### **D20-0021: Applicant and Property Owners is Panchaksha Patel – 2480 Byron Road**

**PUBLIC HEARING TO CONSIDER A DEVELOPMENT REVIEW APPLICATION FOR THE SANSUB APARTMENTS LOCATED AT 2480 W. BYRON ROAD, ASSESSOR'S PARCEL NUMBER 238-050-20. APPLICANT AND PROPERTY OWNERS IS PANCHAKSHA PATEL. APPLICATION NUMBER IS D20-0021.**

**Response to D20-0021 SANSUB APARTMENT 5<sup>th</sup> Submittal Comments**

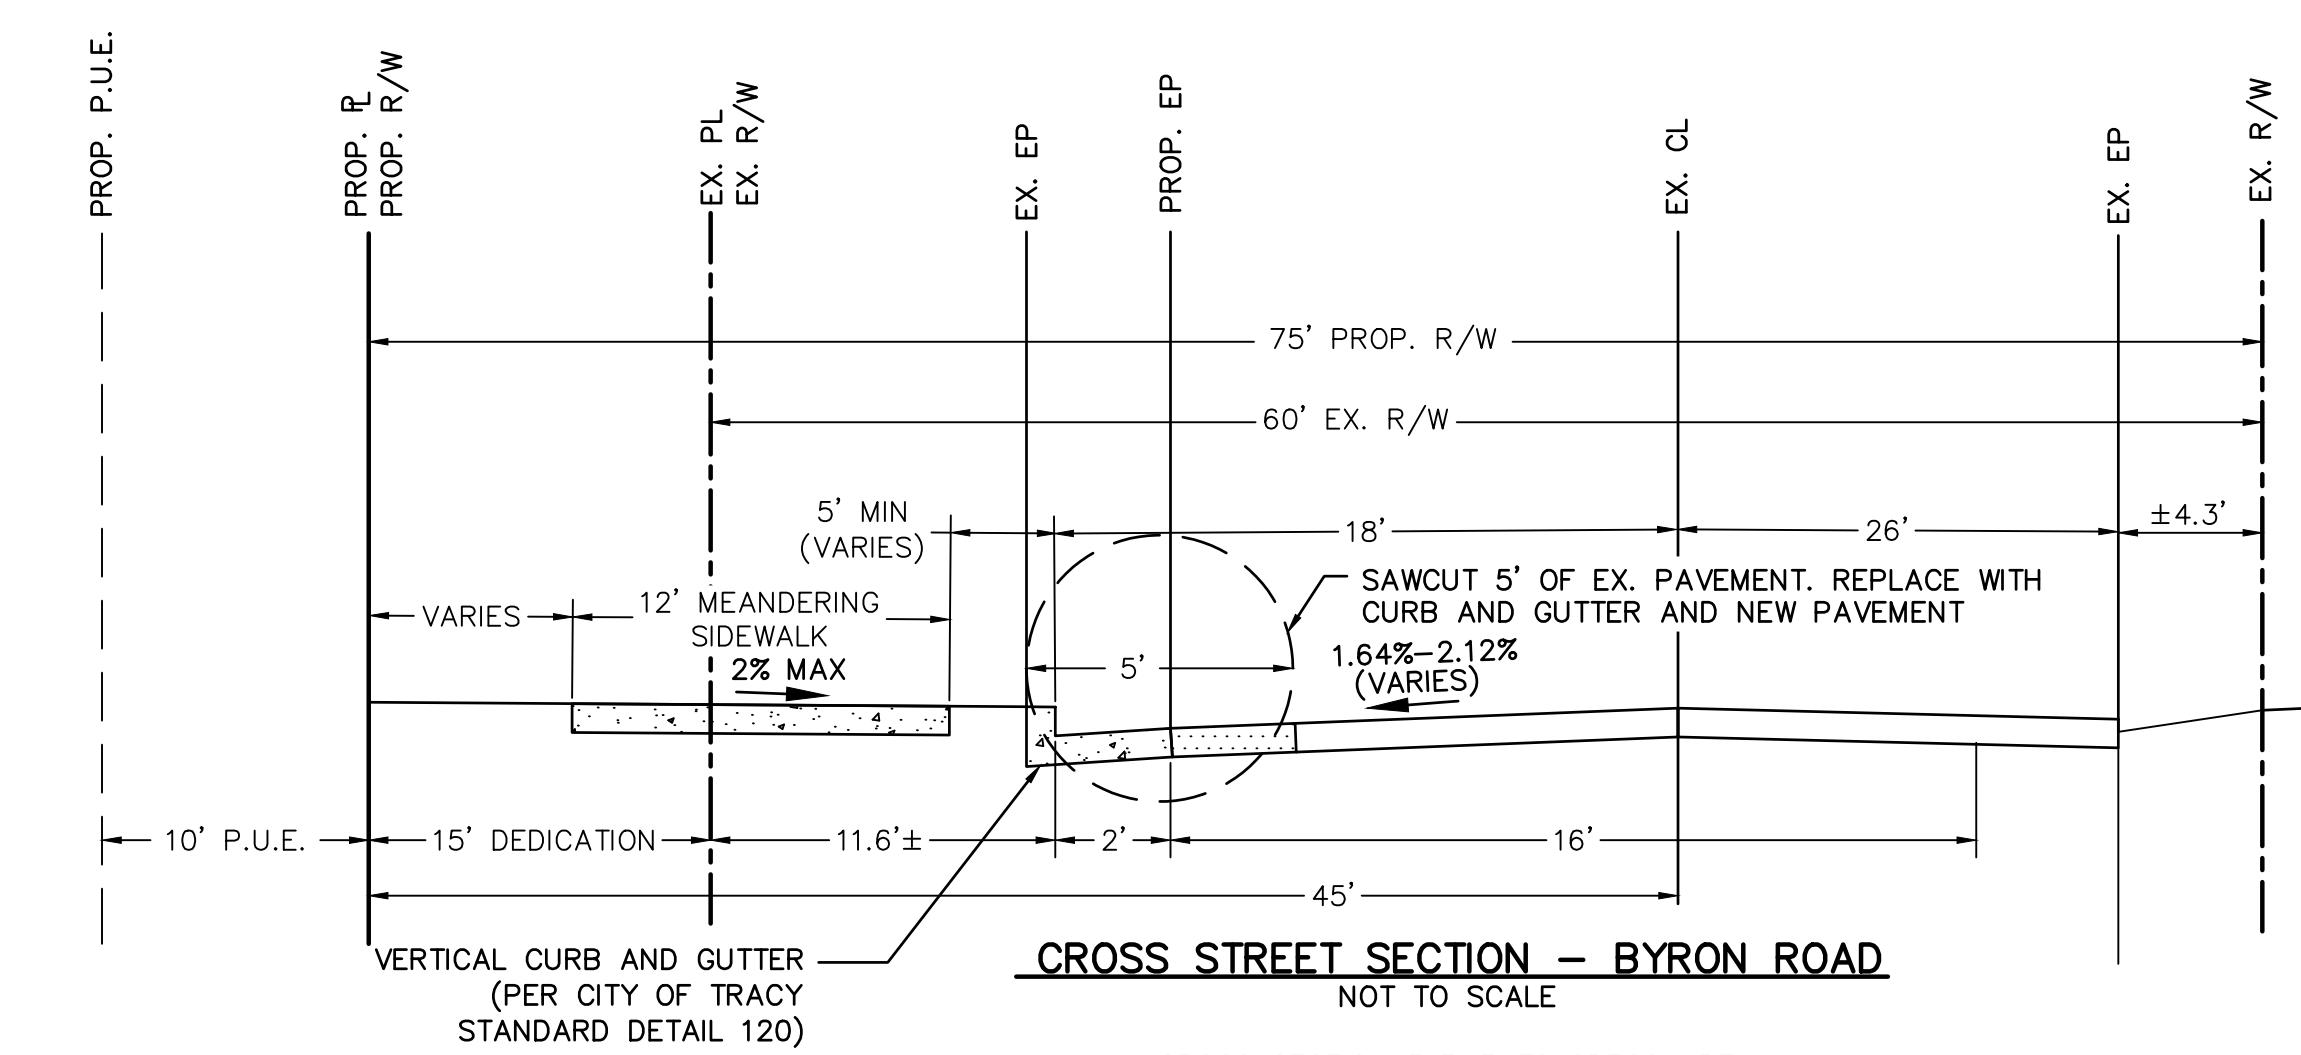
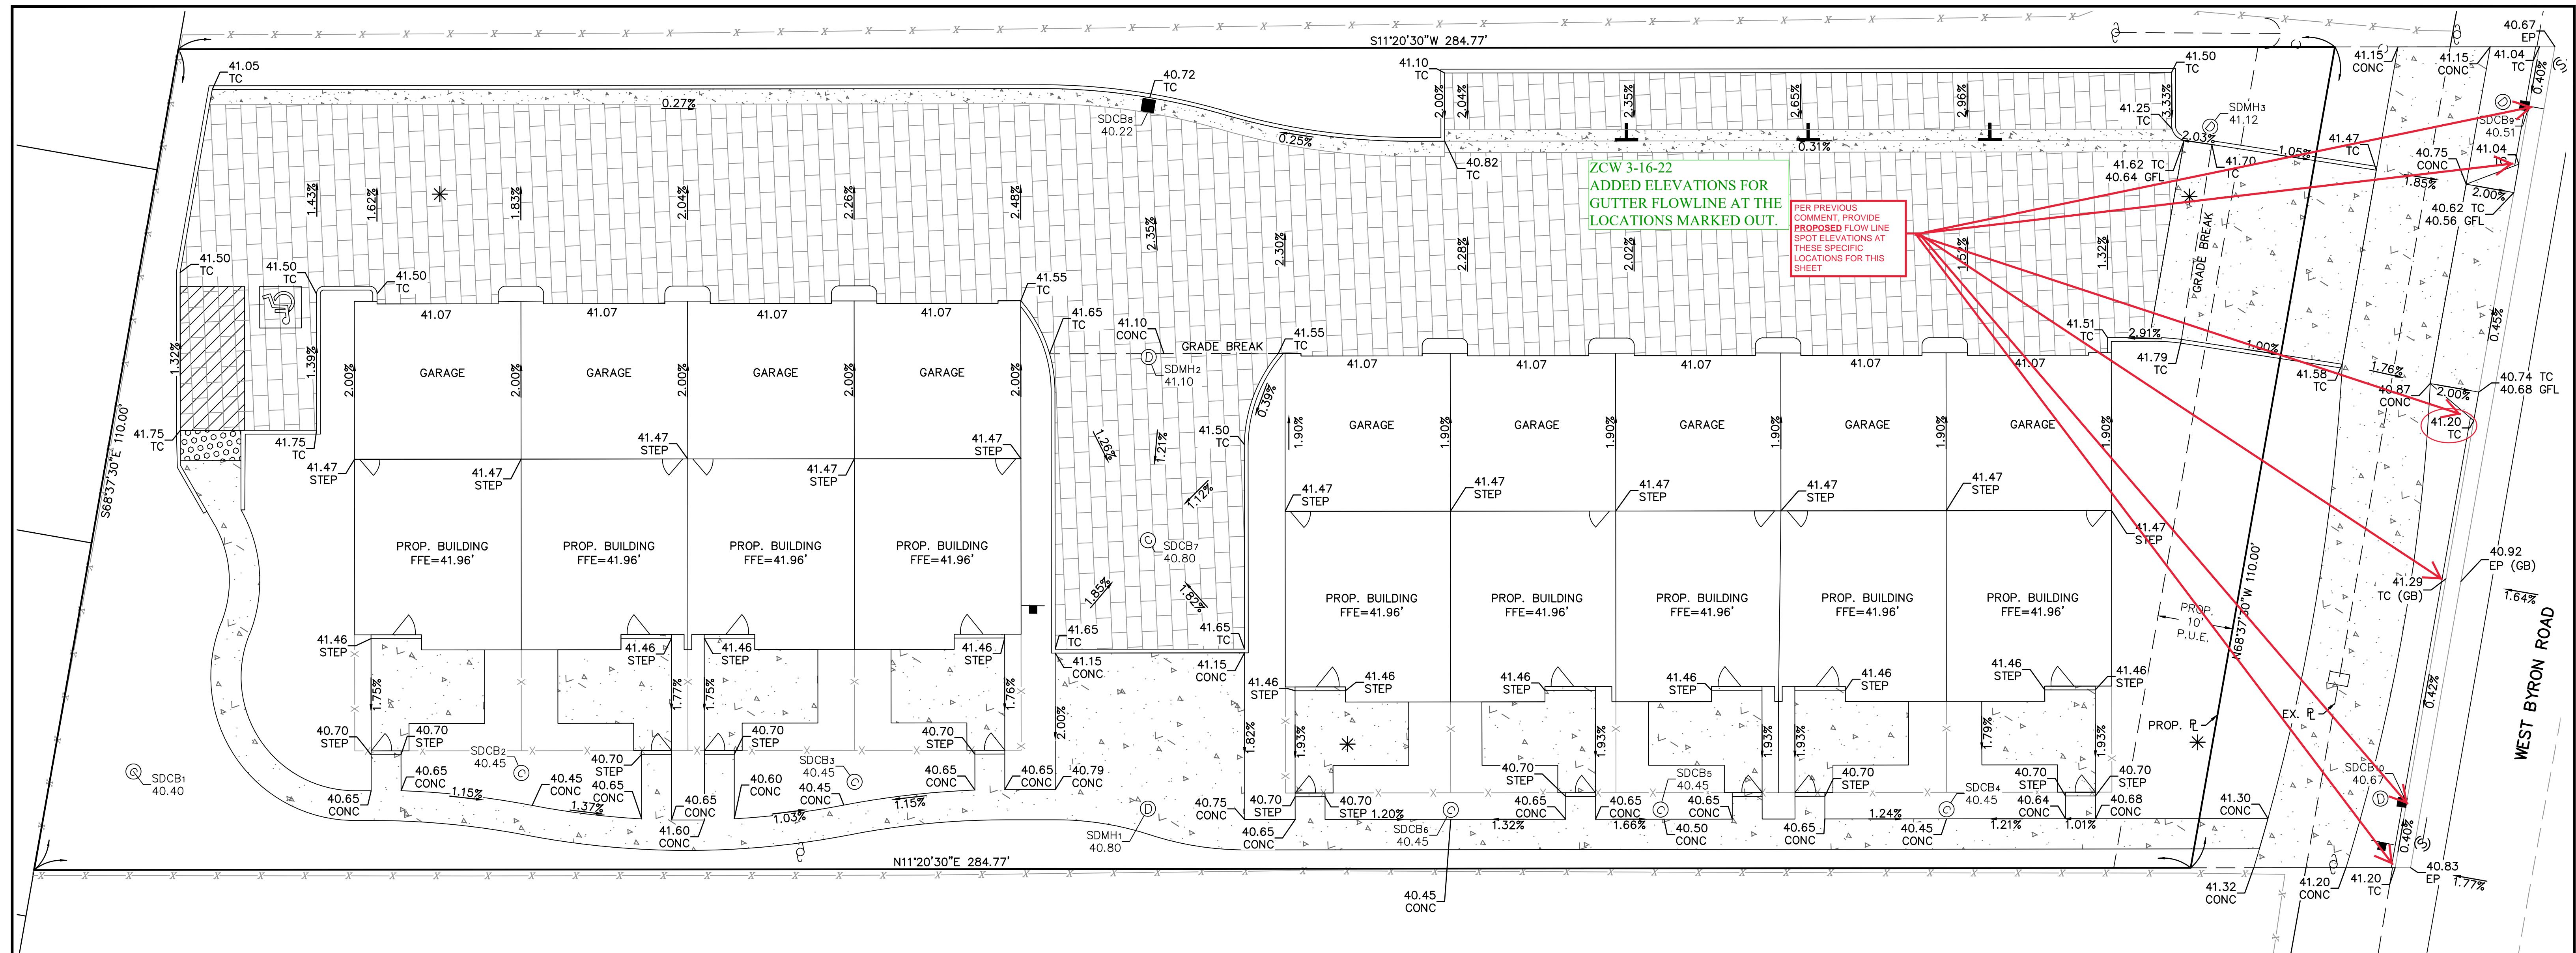
- a. Show detail of how curb and gutter transition to existing improvements on east and west ends of the property.
  - b. Show profile of proposed curb and gutter and how future curb and gutter to the east and west will work. Minimum gutter slope is 0.4%.

**SHOW THIS ON PLAN & PROFILE SHEET.**

*Frontage improvements uses the existing topography and City of Tracy Standard for gutter slope (minimum of 0.40%). A high point was added to achieve this minimum gutter slope, future frontage improvements to the east and west of the project site will need to adhere to City Standards as well as existing street conditions. Our project scope is only responsible for the frontage improvements adjacent to the property boundary.*
